MONTGOMERY COUNTY PLANNING DEPARTMENT THE
 MARYLAND-NATIONAL CAPITAL PARK AND PLANNING COMMISSION

DATE: July 1, 2010

SUBJECT: Development Plan Amendment No: 10-2: Battery Lane, LLC, is a request to add 10 feet 8 inches to the height of the previously approved residential building for a maximum building height of 90 feet, consisting of approximately 22,618 feet of land in the PD-75 zone, located at NW corner of Woodmont Avenue and Battery Lane.

STAFF RECOMMENDATION: Disapprove.

EAST ELEVATION

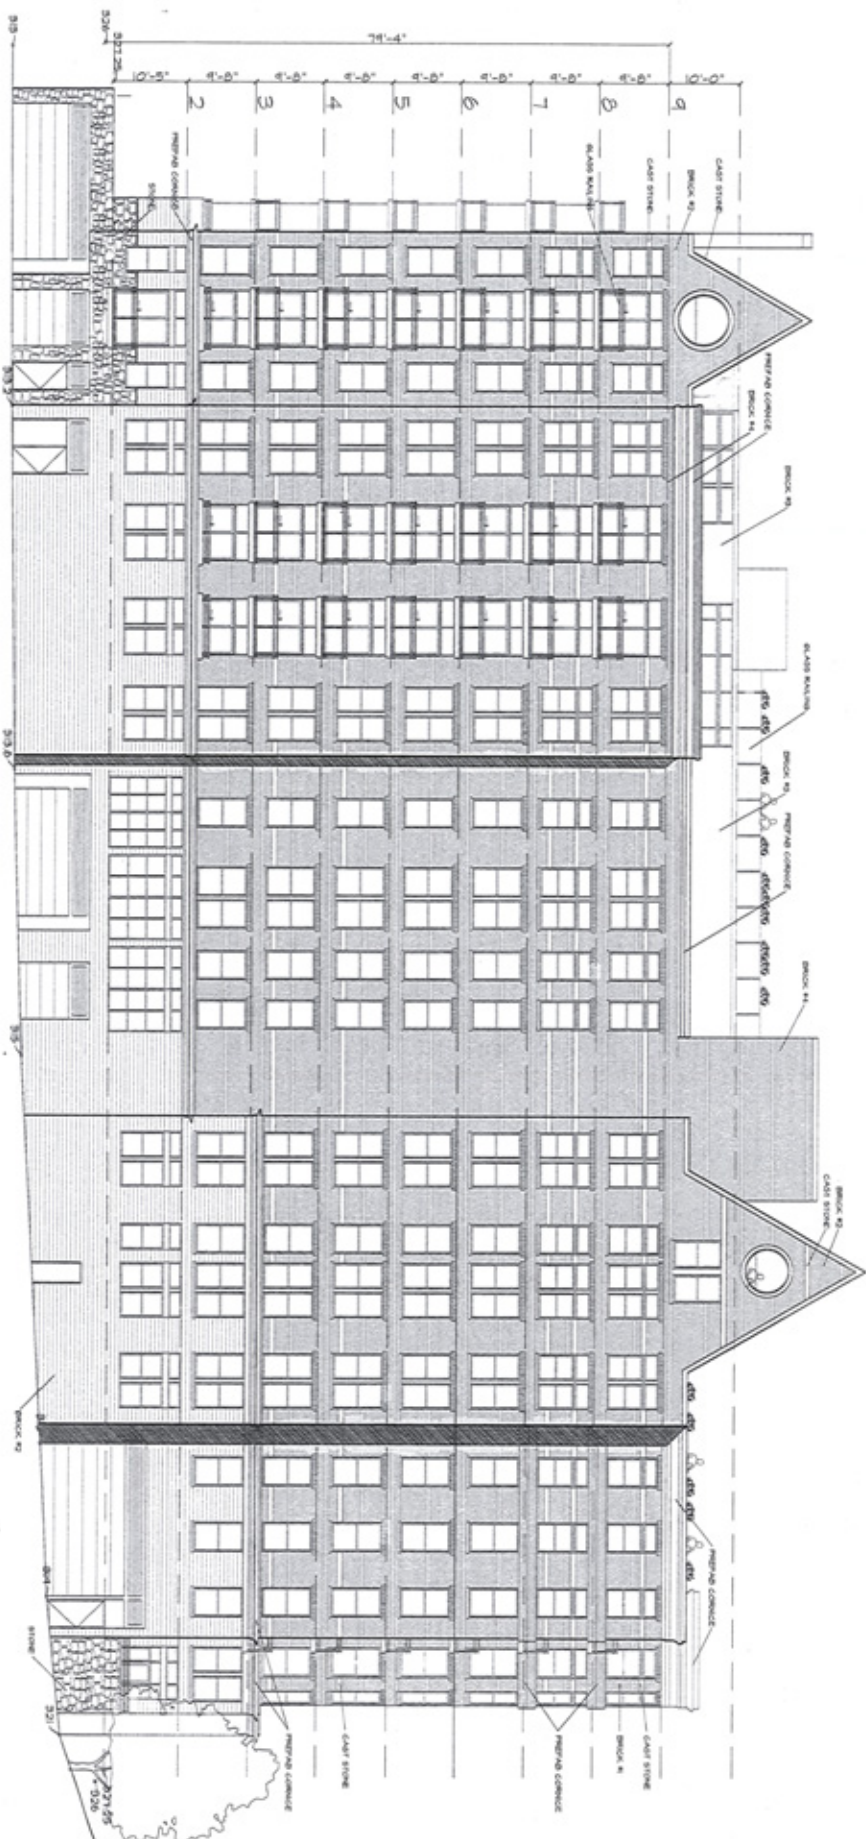
Although there are benefits associated with the development proposal, increasing building height 25 feet above the sector plan established 65 feet height limit is a substantial departure from the Sector Plan and not supported by staff.

In order to make these improvements to the building, the applicant is proposing to increase the building height from 79 feet 8 inches to 90'. The additional height is compatible with the surrounding area heights. It is surrounded by buildings that are up to 100 or more feet in height. However, the 90' is in conflict with the 65' height limit established in the 1994 Bethesda CBD sector plan. And though the site is within the Woodmont Triangle Amendment's boundaries, the zoning and height limits in the Battery Lane District were unchanged. Therefore, in every review of this case Community-Based Planning staff has maintained that the project is in conflict with the 1994 Bethesda CBD Sector Plan 65' height limit recommendation for this site. Community Based Planning staff does not support increasing the approved building height from 79 feet 4 inches to 90 feet as proposed by the applicant.

After a careful review of the proposed development plan amendment, staff concludes that although there are benefits associated with the development proposal, increasing building height 25 feet above the sector plan established 65 feet height limit is a substantial departure from the sector plan that is not supported by staff. A deviation from a sector plan guideline is a reasonable trade-off for the construction of MPDUs that might not otherwise be realized, but must be considered in context of sector plan objectives. In granting DPA-06-1, in 2007, the District Council found that the 79' feet and 4 inches height is practical, functional and economically feasible (for the applicant) allowing reasonable flexibility to achieve the maximum extent required to accommodating the eight MPDU units. The current proposal does not offer an increase in the number of MPDUs
